HIA ADDENDUM

CHEDOKE BROWLANDS

828 SANATORIUM ROAD

03 APRIL 2022

PROPOSED TRAIL NETWORK [Urban Design Brief, [MSAi]

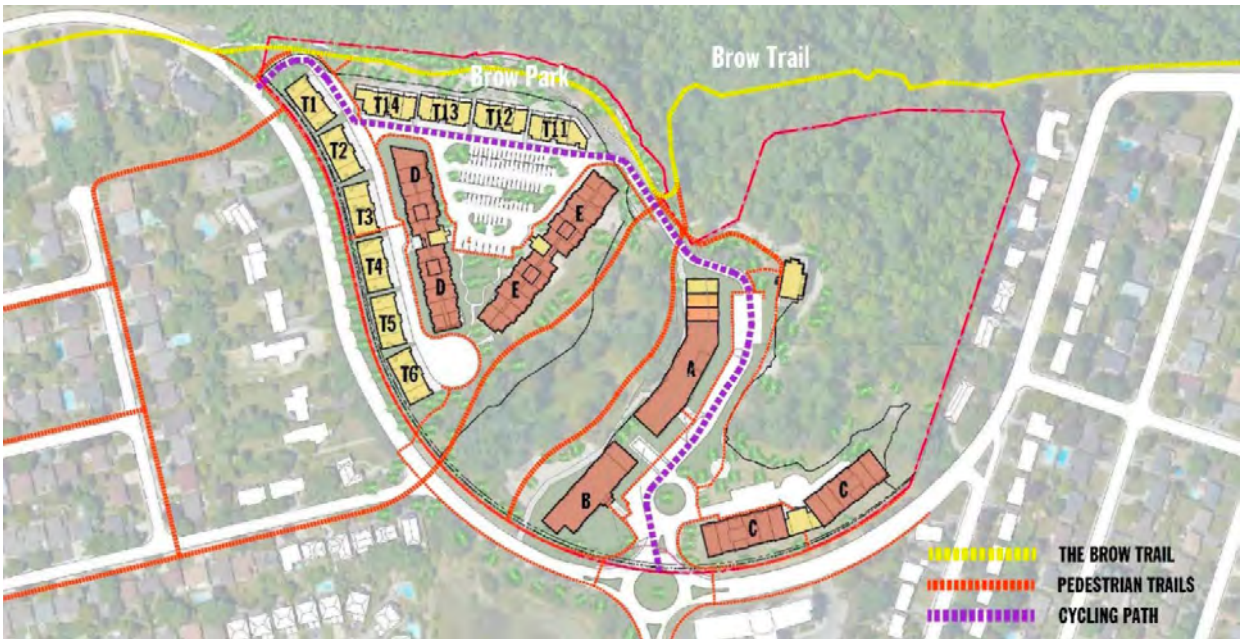
The existing curvilinear form and siting of Sanatorium Road through the middle of the site has been identified as a feature of the Cultural Heritage Landscape (CHL) in the Chedmac Secondary Plan. The subject proposal includes the closure of the road.

The Chedmac Secondary Plan notes that the curvilinear street pattern should be maintained and/or referenced in the new development and the existing curvilinear road alignment of old Sanatorium Road shall be respected, where technically feasible. Should Sanatorium Road be closed, options should be considered to replace this pathway to provide public access stretching north of the proposed parking lot on the east side of the site and past the front yard of the Long & Bisby building towards the northwest section of the site and the Brow Trail. The public access function and curvilinear pattern of Sanatorium Road should be referenced in any new pathway and may include a pedestrianized connection that follows the same approximate route as the current road and links to different areas of the site while providing views and public access to the building.

Response: Integration of curvilinear street pattern

The revised proposal includes a network of publicly accessible pedestrian and cycle paths through the site that approximate the curvilinear road alignment of old Sanatorium Road. This path network will provide public access through the site from the curved perimeter road (Scenic Drive) to the escarpment brow. The paths will link different areas of the site and provide views and access to heritage features including the Chedoke Creek Corridor, the Cross of Lorraine, the stone pillars and stone wall, the Escarpment Steps, and the Long & Bisby Building.

1 BUILDING A UNDERGROUND PARKING STRUCTURE
2 UNDERGROUND STORMWATER MANAGEMENT TANK
3 PAVED ROAD

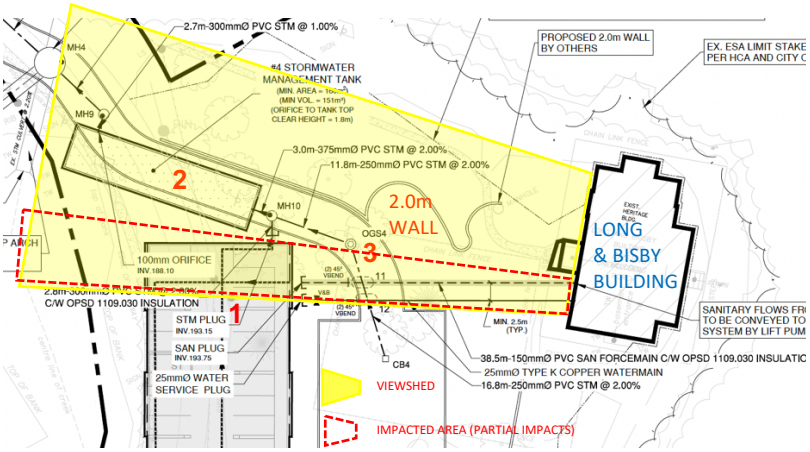
The submitted Tree Preservation Plan indicates that there are a number of native, healthy and mature trees in the immediate vicinity of the Long and Bisby building that are proposed to be removed or injured. The mature trees are a key element of the CHL that signify the lasting heritage and longevity of the site and contribute to its park-like setting and their value cannot easily be replaced with new plantings. Every effort should be made to preserve the mature, healthy trees identified in the Tree Preservation Plan surrounding the Long & Bisby building to maintain the park-like setting both identified as a heritage attribute in the property's designation by-law and contributing to the value of the CHL. Consideration should be given towards a development alternative that reduces the extent of the northward siting of the eight- storey 'Building A' and its associated underground parking. This may prevent the removal of all the mature trees in the vicinity of the Long & Bisby building while also contributing to an enhanced sense of openness of the CHL through visual connectivity to the open space area in the middle of the site.

There are a number of memorial trees on-site that will be removed. A plan should be prepared to identify the significance of these trees and to mitigate the adverse impact resulting from their removal. This may be included as part of a revised Cultural Heritage Impact Assessment (CHIA) as noted below.

The Chedmac Secondary Plan notes that the undulating topography is a feature of the CHL. Every effort should be made to maintaining the existing topography and to design the new development to be integrated within the existing topography and avoid extensive regrading wherever feasible.

Response: Integration of Sense of Openness of Park-like Setting:

The revised proposal includes two step-downs at the north end of Building A as a means of reducing negative impacts on the open area in front of the Long & Bisby Building. As previously noted, the openness of the site will be maintained from the north edge of Building A to the Escarpment, so the impacts of Building A are partial and the revised site plan further reduces those impacts. In addition, the northward extant of Building A has been moved back approximately 4.0 m and the existing grade has been matched along the roadway.

As previously noted, the park-like setting to the north and east of the Long & Bisby Building will be maintained through preservation of the Woodlot and the wooded areas along the Escarpment Brow. Impacts on the park-like setting are limited to the areas to the west and south of the Long & Bisby Building. The updated *EIS* indicates that 3 trees in this area can be preserved and 26 trees will be removed.

HISTORIC LAYOUT (Chedoke; More than a Sanatorium)

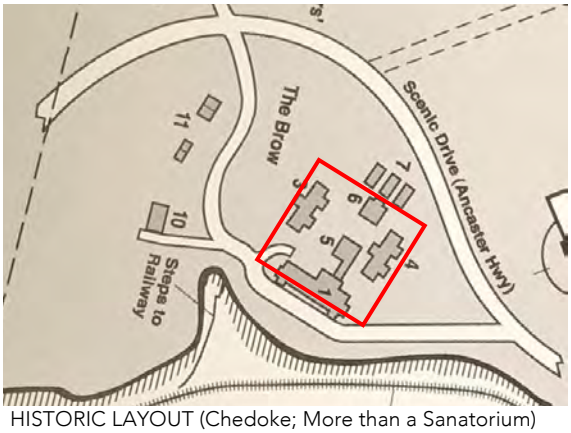
The Chedmac Secondary Plan requires that the design of new buildings is sympathetic to both the historical significance of the Chedoke Browlands and to the heritage architecture. While it is not desirable for new buildings to replicate the appearance of the heritage architecture, the new buildings should be designed in a contemporary style while taking design cues from the heritage structures including the Long & Bisby building and those that have been demolished as shown in historical photos.

Additionally, the Chedmac Secondary Plan requires that a new building to be constructed in the same approximate building footprint of the demolished Brow Infirmary building on the northwest section of the site shall be designed to respect the heritage architecture of the original building to a maximum height of 4 storeys. It does not appear that any of the new buildings on the northwest section of the site reflects the previous siting of the demolished Infirmary building.

The revised proposal includes a layout for the West Block that better responds to the layout of the former hospital buildings. The low-rise Townhouses facing the brow approximate the siting of the former Brow Infirmary. The height of the mid-rise blocks behind the Townhouses has been reduced from 8 storeys to 5 storeys to that they are more in keeping with the former 4-storey hospital buildings. The mid-rise blocks are arranged in a triangular formation rather than the U-shaped formation of the former Brow infirmary with separate East and West Pavilions at the rear. A triangular formation is proposed for the new development so that three buildings of a similar size can be built in this area, rather than one long building that blocks views to the escarpment with smaller support buildings behind it. The triangular formation will enclose a parking lot and entrance to the underground parking garage. This

URBAN DESIGN BRIEF (MSAi) – two new pedestrian trails through the Chedoke Creek Greenway are proposed

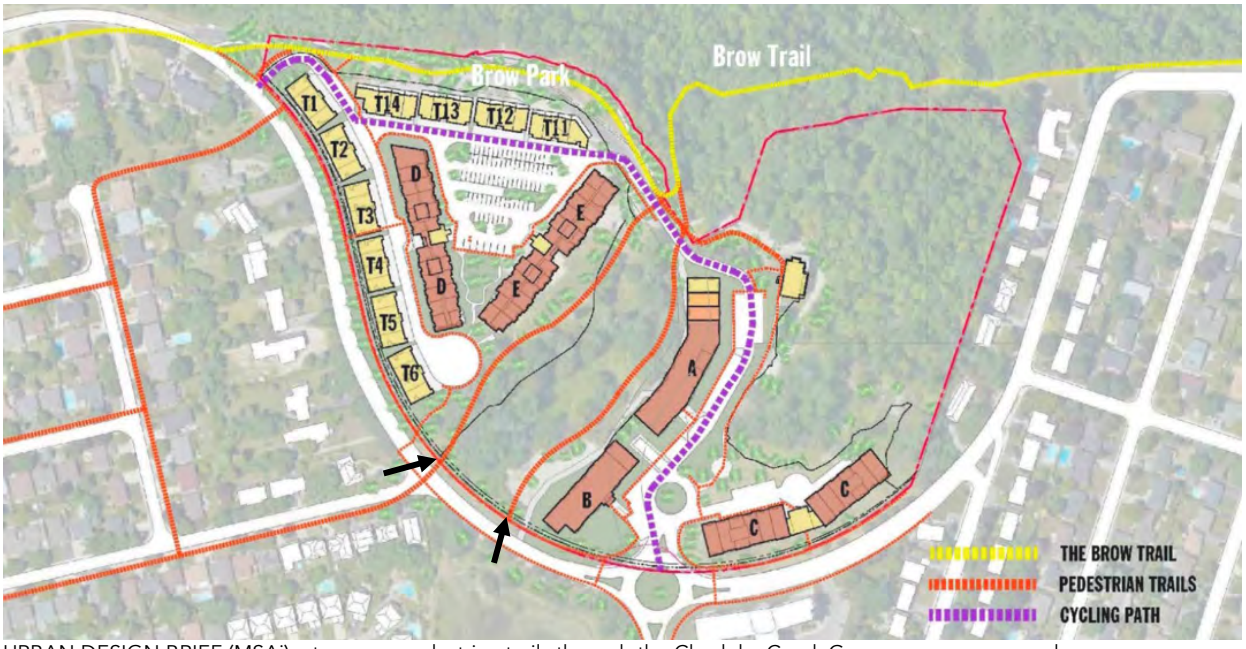
It appears that a majority of the remaining built heritage structures including the stone wall and pillars located between Sanatorium Road and the Brow's edge, the Cross of Lorraine and Long & Bisby building will be preserved within the new development. The pedestrian bridge over the Chedoke Creek has been noted as having heritage value as part of the CHL within the Chedmac Secondary Plan and it is being proposed to be removed. More information regarding the heritage value of the bridge and whether there is a plan for its salvage and/or reuse should be provided.

Response: Identification and Protection of Built Cultural Heritage Landscape Features
